ADDENDUM NO. 3

DATE: February 7, 2024

PROJECT: Benton Washington Regional Public Water Authority
Phase 1A – Water Treatment Plant Improvements – High Service Pump Station
Rogers, Arkansas

ROOF PLAN
SCALE: 3/16" = 1'-0"

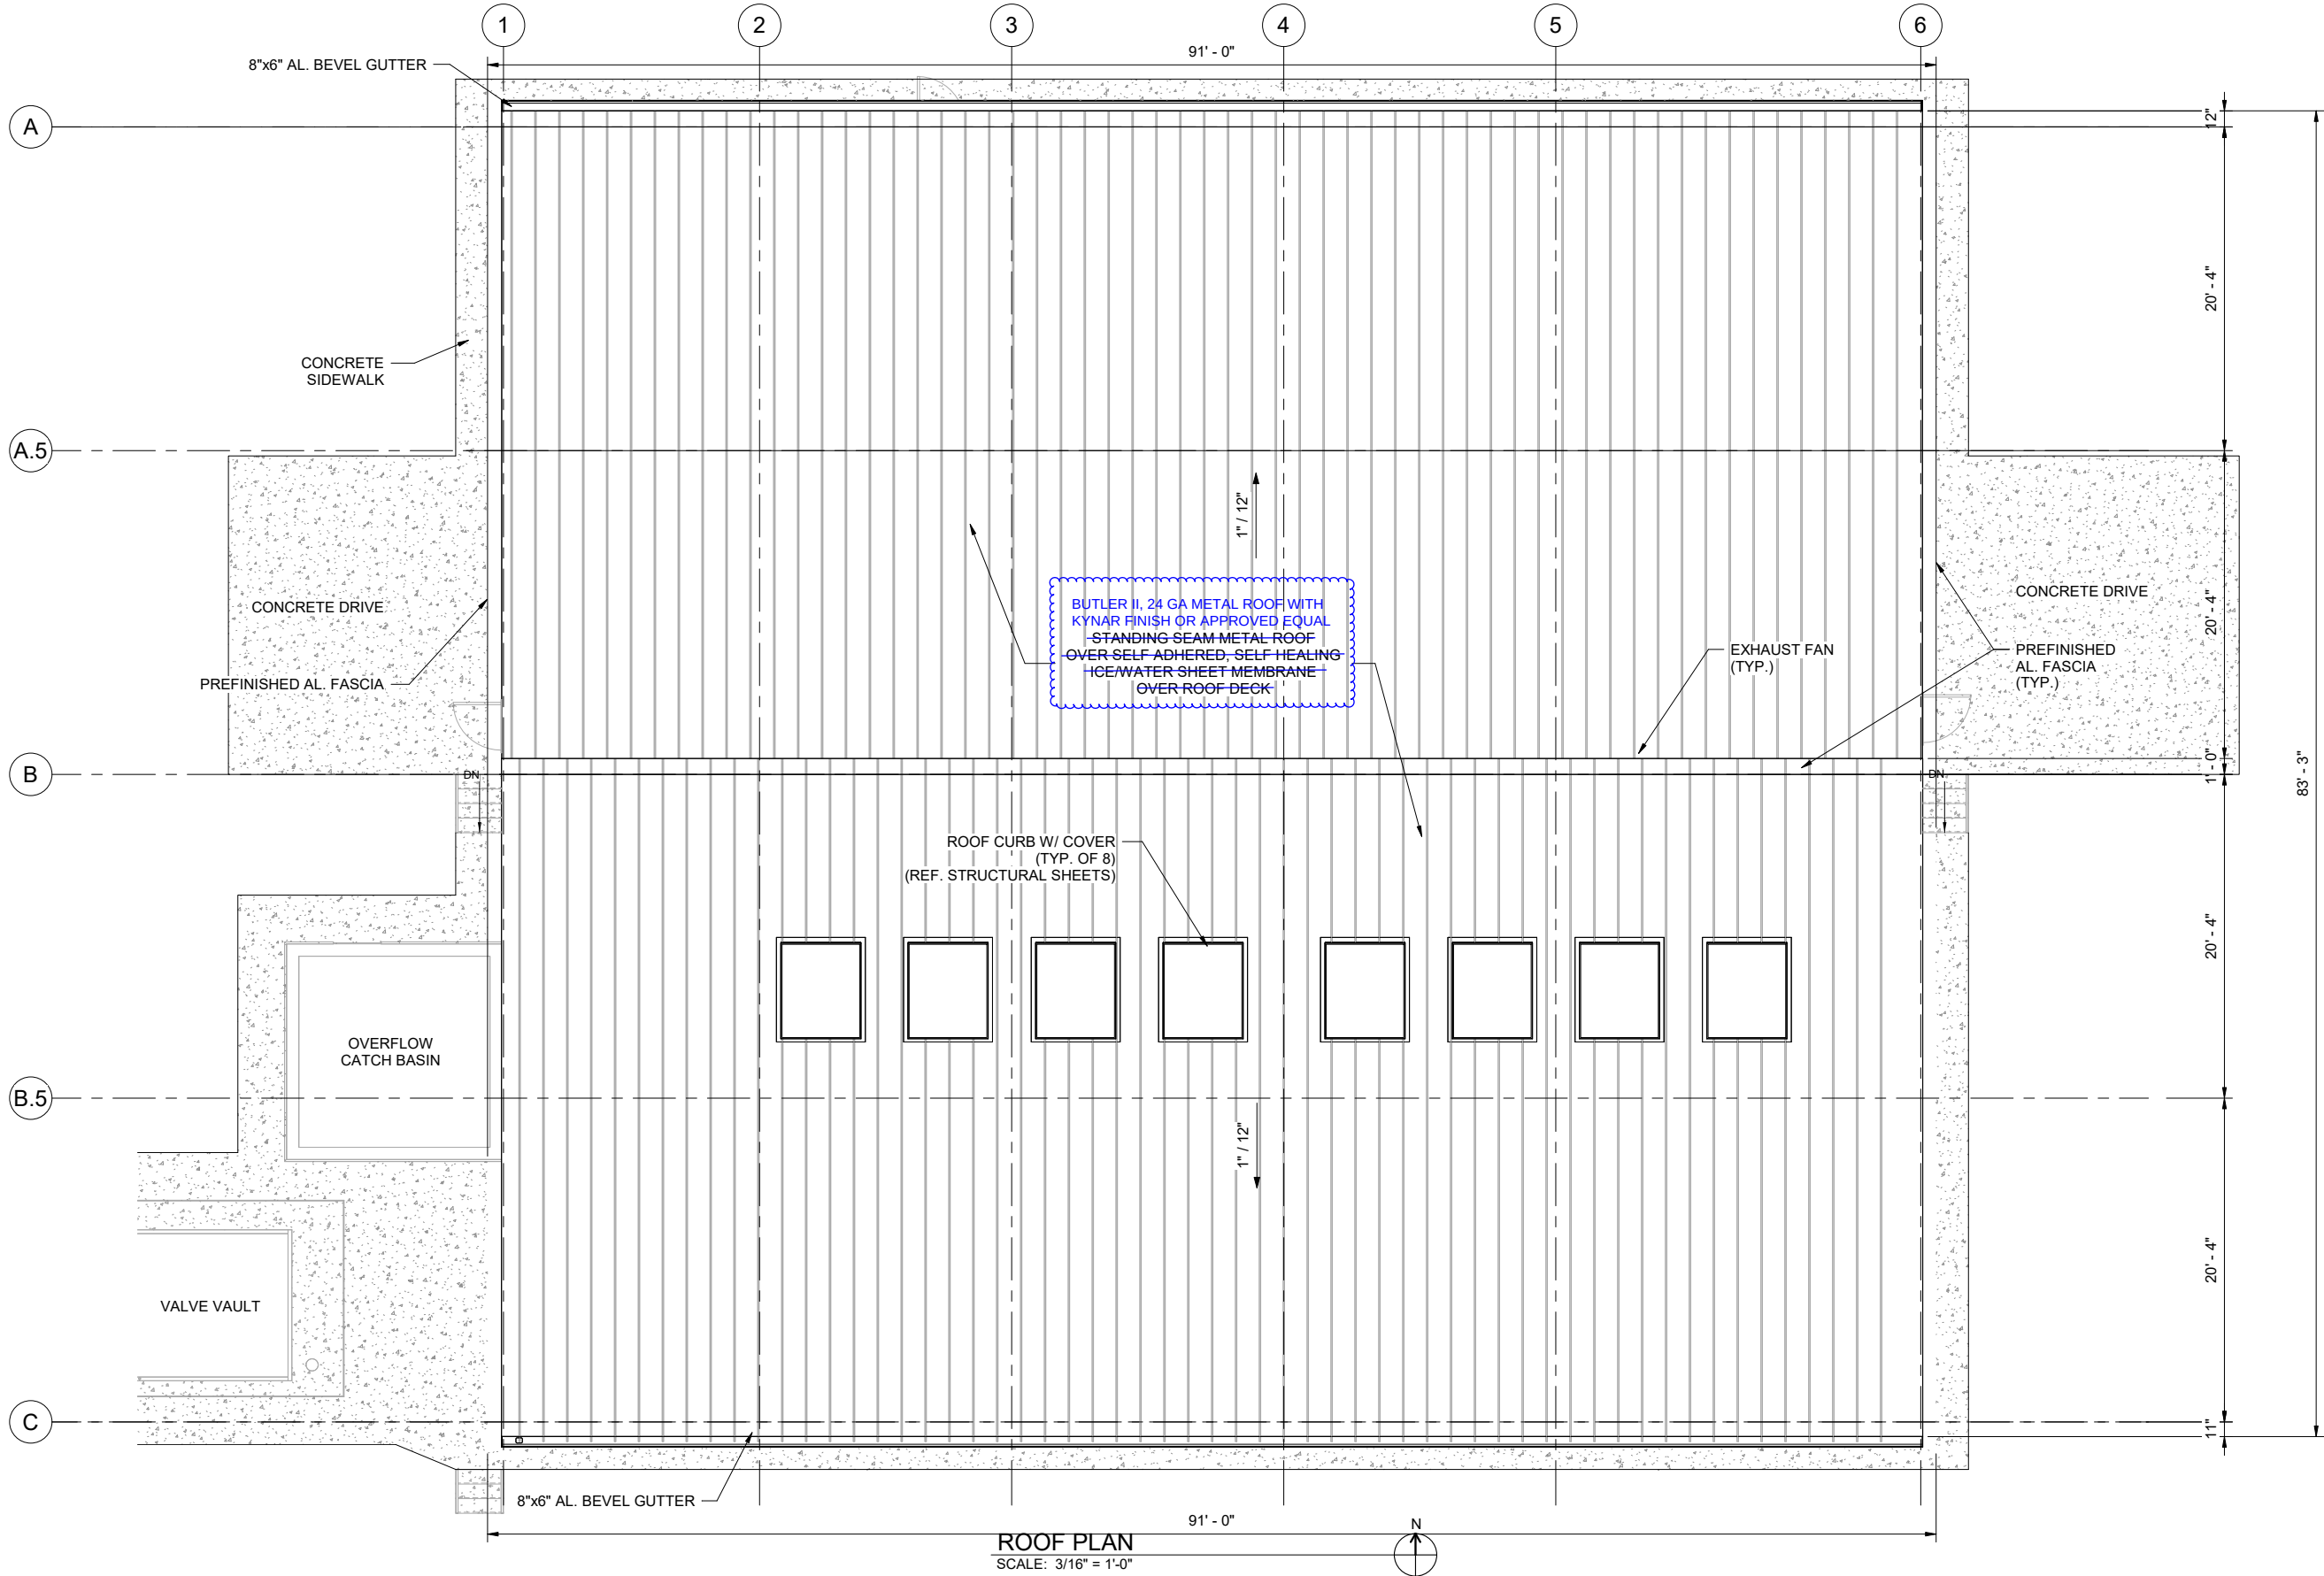
REV. NO.	DATE	DRWN	CHKD	REMARKS
2	02-06-24	CEI	JDM	ADDENDUM NO. 3, MODIFIED ROOF NOTES
1	1-31-24	CEI	JDM	ADDENDUM NO. 2, MODIFIED ELECTRICAL EQUIPMENT LOCATIONS AND REMOVED SIGN

RODGERS, ARKANSAS
CAPITAL IMPROVEMENTS PLAN PHASE IA
WATER TREATMENT PLANT IMPROVEMENTS
CONSTRUCTION DOCUMENTS
HIGH SERVICE PUMP STATION
BUILDING ELEVATIONS - NORTH AND SOUTH

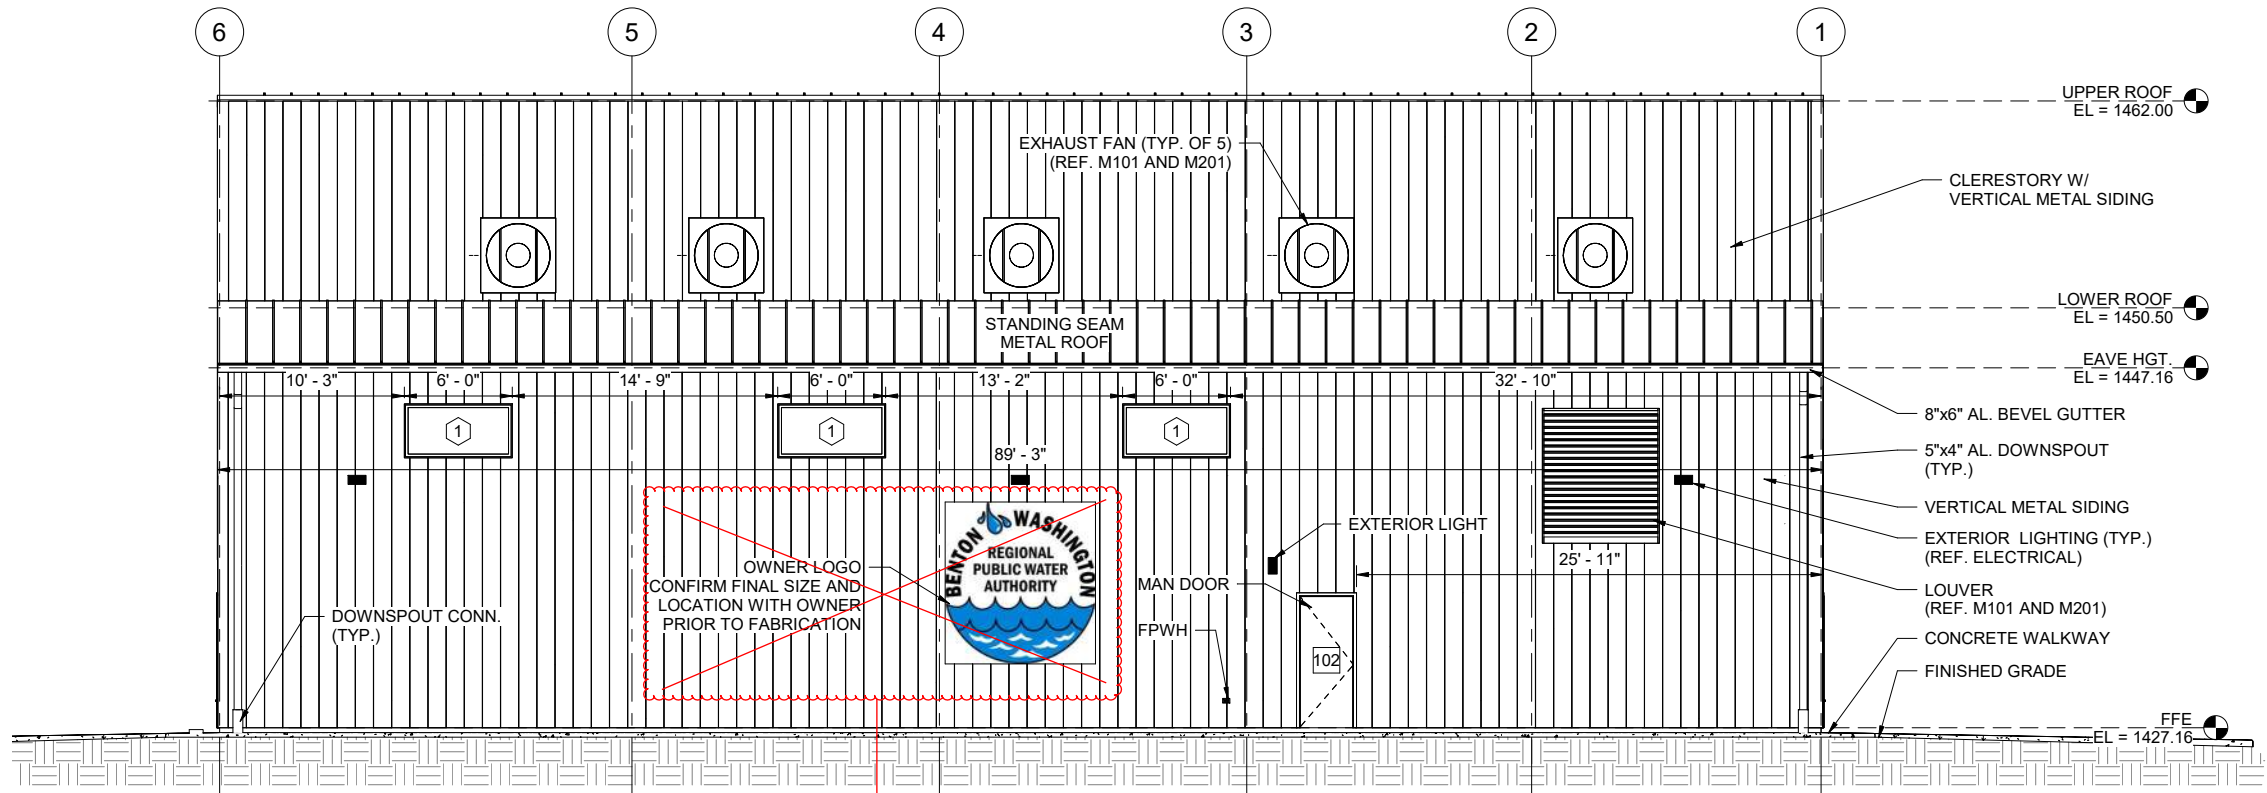
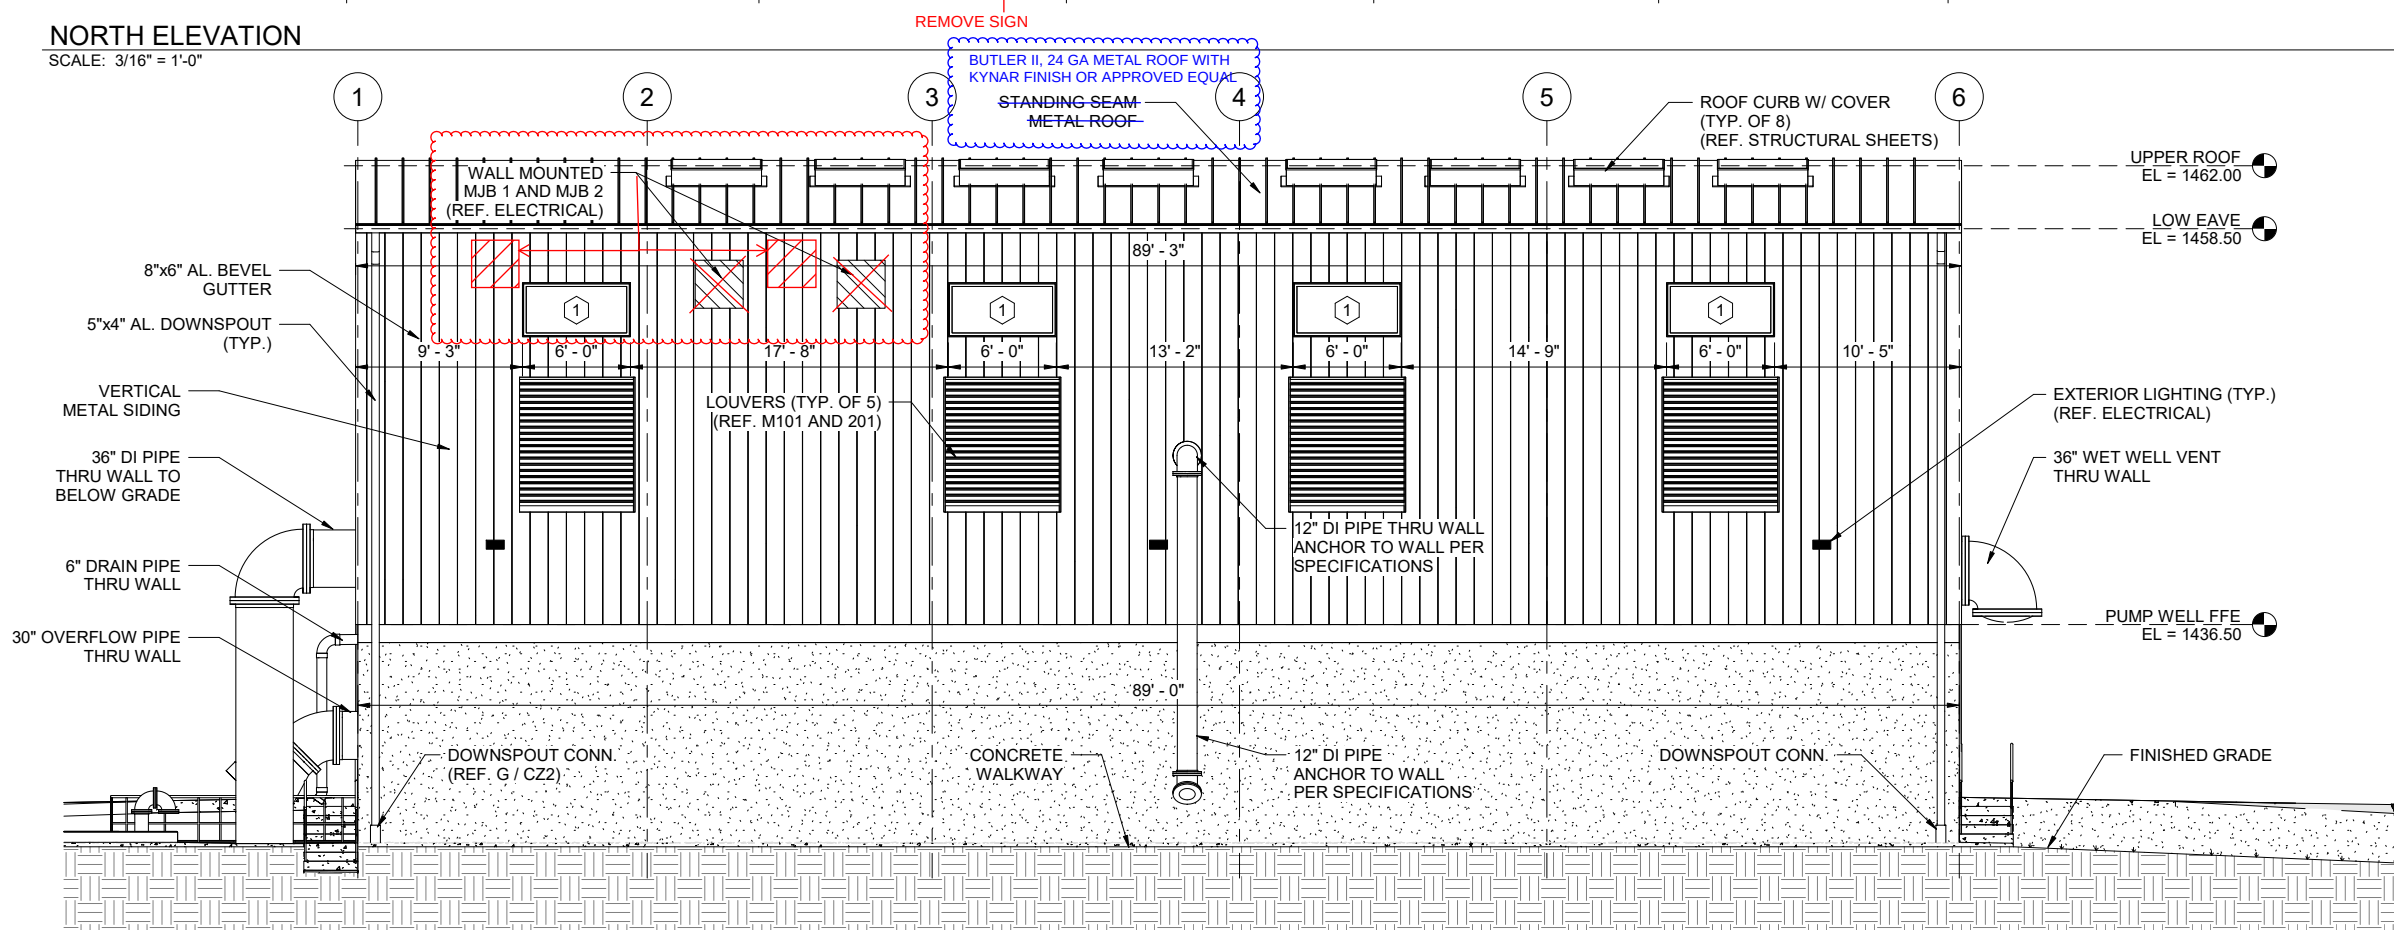
REV. NO.	DATE	DRWN	CHKD	REMARKS
2	02-06-24	CEI	JDM	ADDENDUM NO. 3, MODIFIED ROOF NOTES
1	1-31-24	CEI	JDM	ADDENDUM NO. 2, MODIFIED ELECTRICAL EQUIPMENT LOCATIONS AND REMOVED SIGN

MECHANICAL PROCESS PIPING PLAN
SCALE: 3/16" = 1'-0"

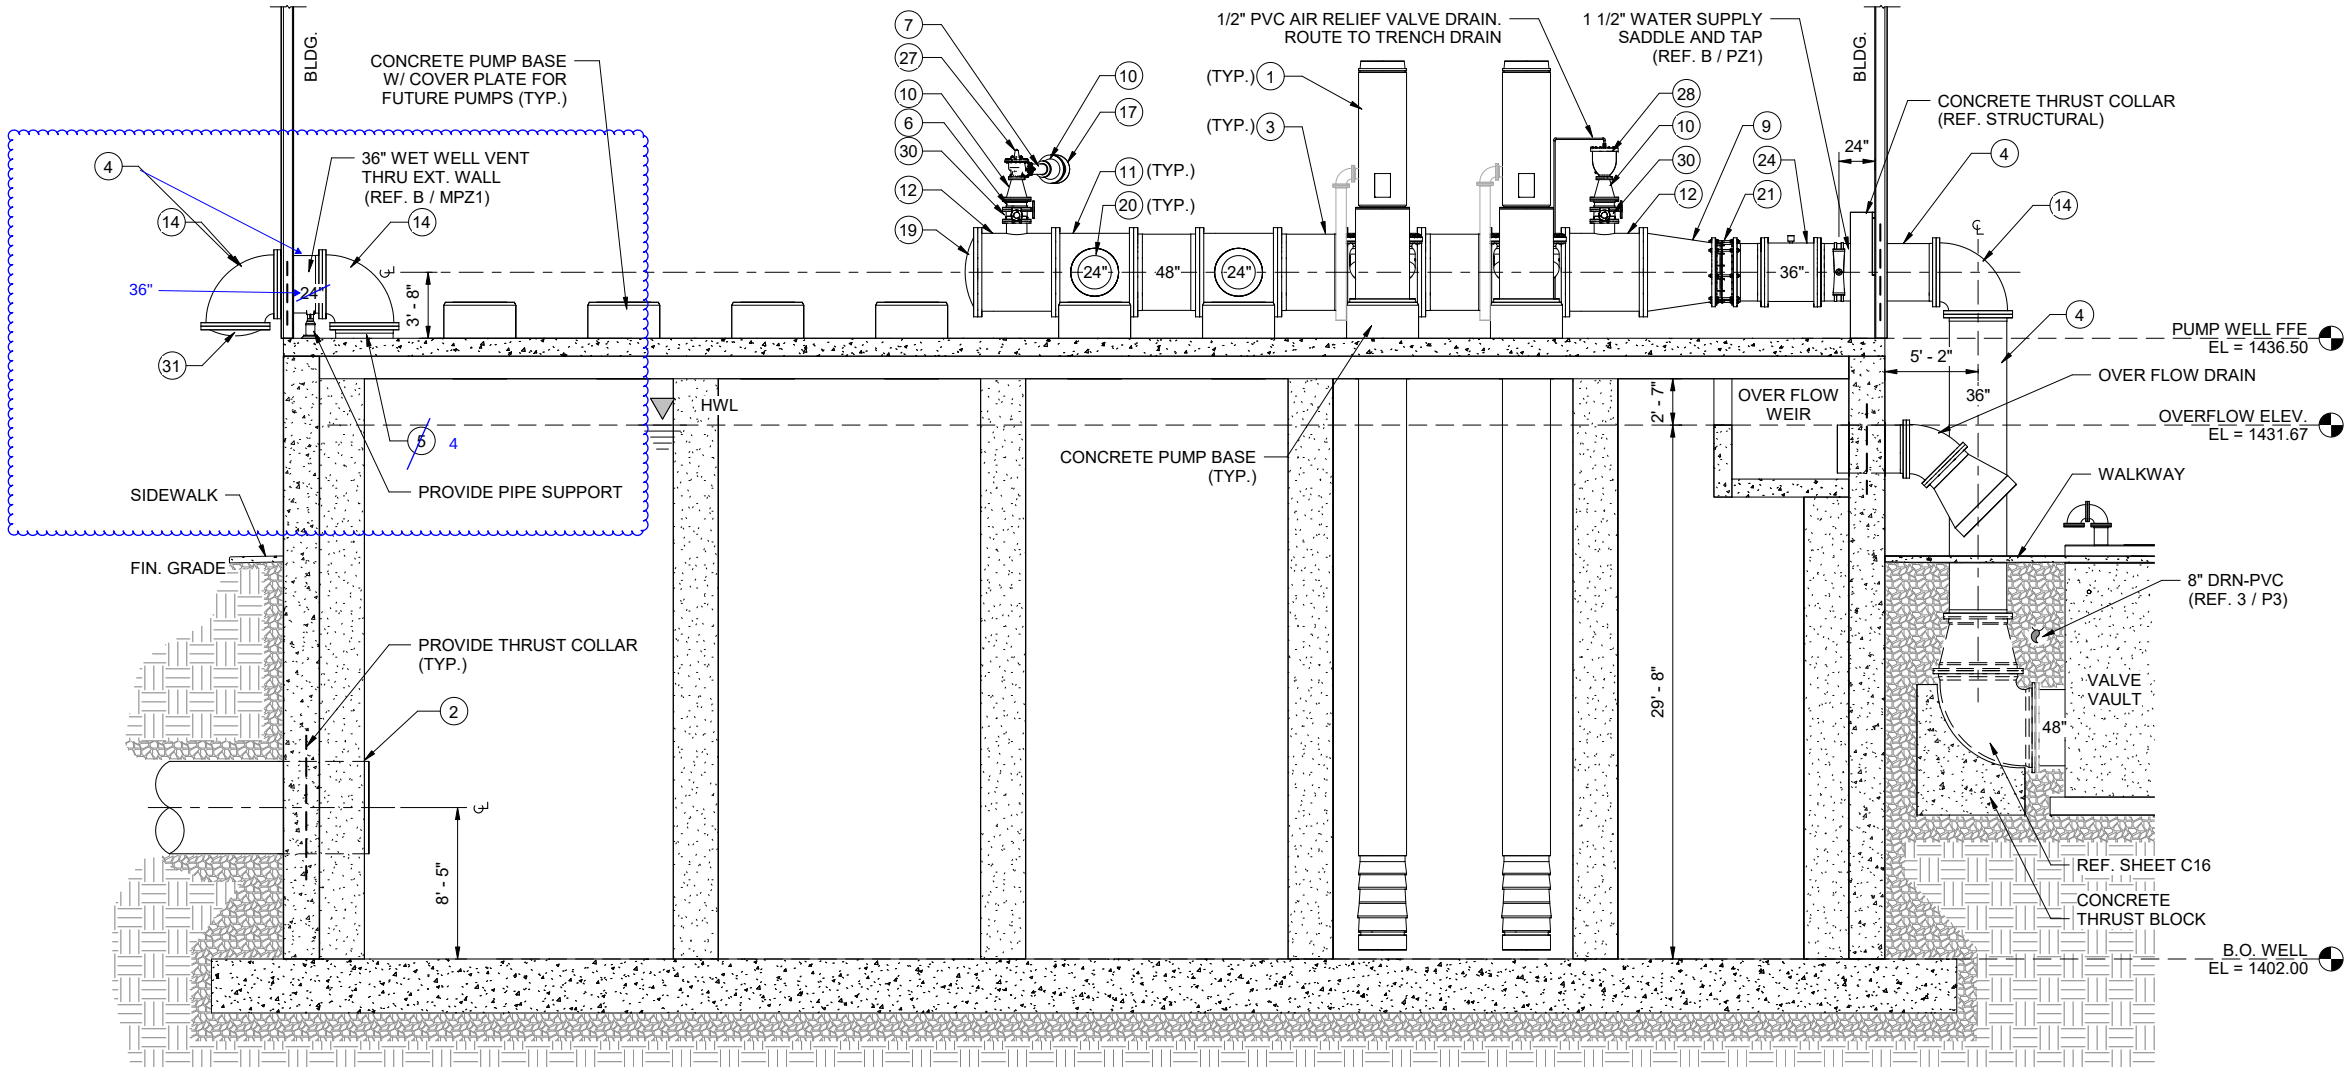
REV. NO.	DATE	DRWN	CHKD	REMARKS
2	02-06-24	CEI	JDM	ADDENDUM NO. 3, REVISED EQUIPMENT SCHEDULE MARKS
1	1-31-24	CEI	JDM	ADDENDUM NO. 2, REVISED SCHEDULED EQUIPMENT MARKS
